HISTORIC AND DESIGN REVIEW COMMISSION

April 04, 2018

HDRC CASE NO: 2018-067
ADDRESS: 427 ADAMS ST
LEGAL DESCRIPTION: NCB 2880 BLK 5 LOT 7&8
ZONING: RM-4
CITY COUNCIL DIST.: 1
DISTRICT: King William Historic District
APPLICANT: James Ed Carleton
OWNER: Elaine and Rick Lutton
TYPE OF WORK: Construction of a rear addition - Final approval
APPLICATION RECEIVED: March 16, 2018
60-DAY REVIEW: May 15, 2018
REQUEST:

Proposed West Side Elevation

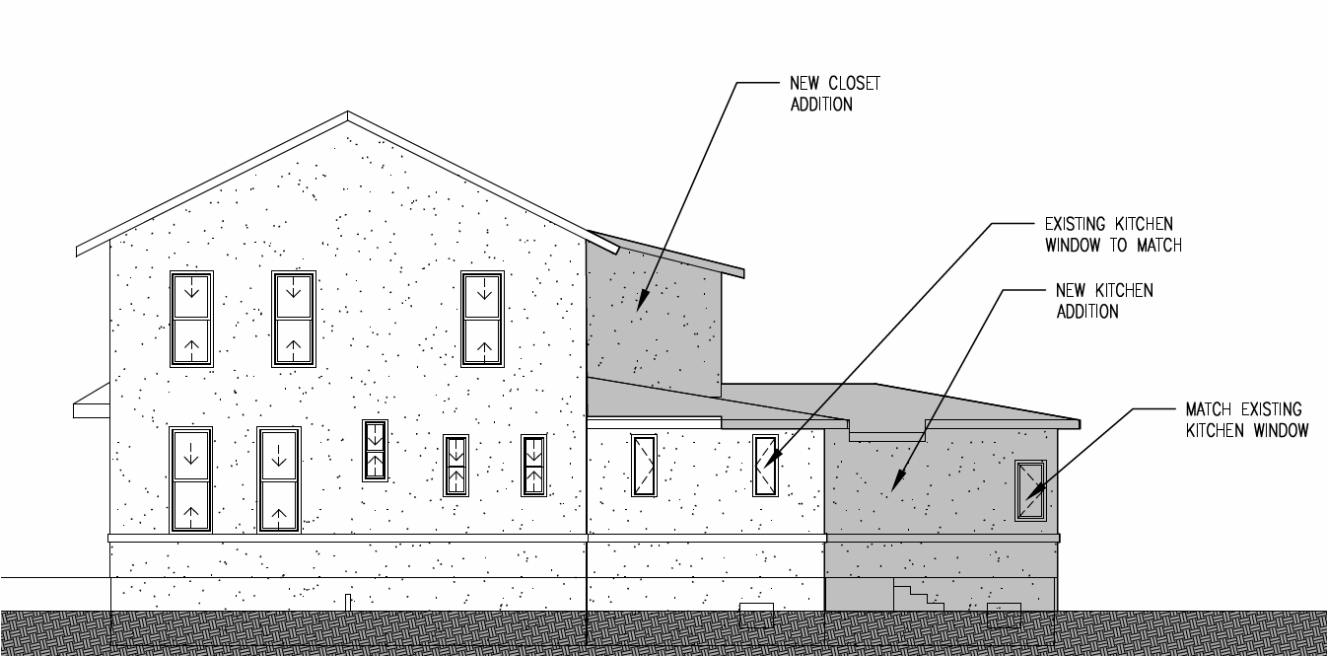
- g. **ARCHITECTURAL DETAILS** – Generally, the proposed addition is appropriate for the style of the primary historic structure and consistent with the Guidelines; however, staff finds that additional window openings that relate to those found in the historic structure should be incorporated into the design.

- i. That the applicant install additional fenestration on the proposed addition to match that of the primary historic structure.
- ii. That the removed windows from the rear of the historic structure be salvaged on site for use in the addition.
- iii. That the applicant submit window specifications to staff. The proposed windows should feature a one over one profile to match those of the primary historic structure. Additionally, The proposed wood windows should feature meeting rails that are no taller than 1.25" and stiles no wider than 2.25". White manufacturer's color is not

Proposed East Side Elevation

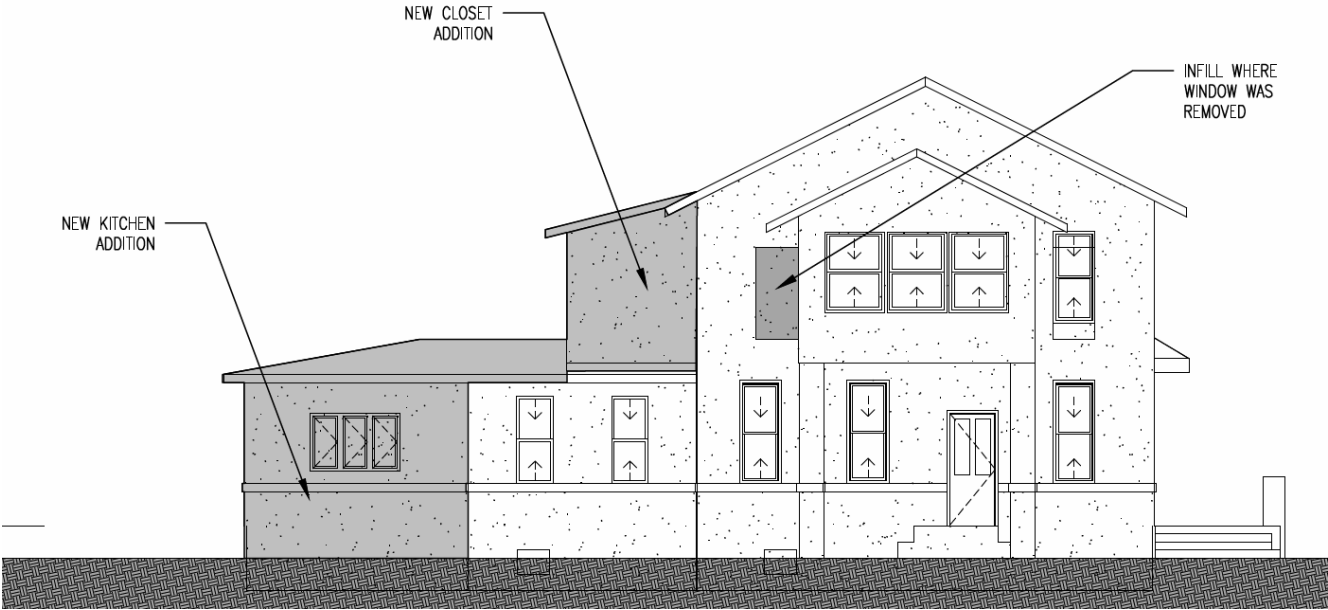
- h. **WINDOW REMOVAL** – To the immediate rear of the side porte cochere, the applicant has proposed to infill an existing window opening. The Guidelines for Exterior Maintenance and Alterations 6.A.i. notes that existing window and door openings should be preserved. The applicant's proposed window removal is not consistent with the Guidelines; however, given its location and low visibility due to the existing porte cochere, staff finds that its removal may be appropriate if the existing window is repaired and installed in the proposed addition.
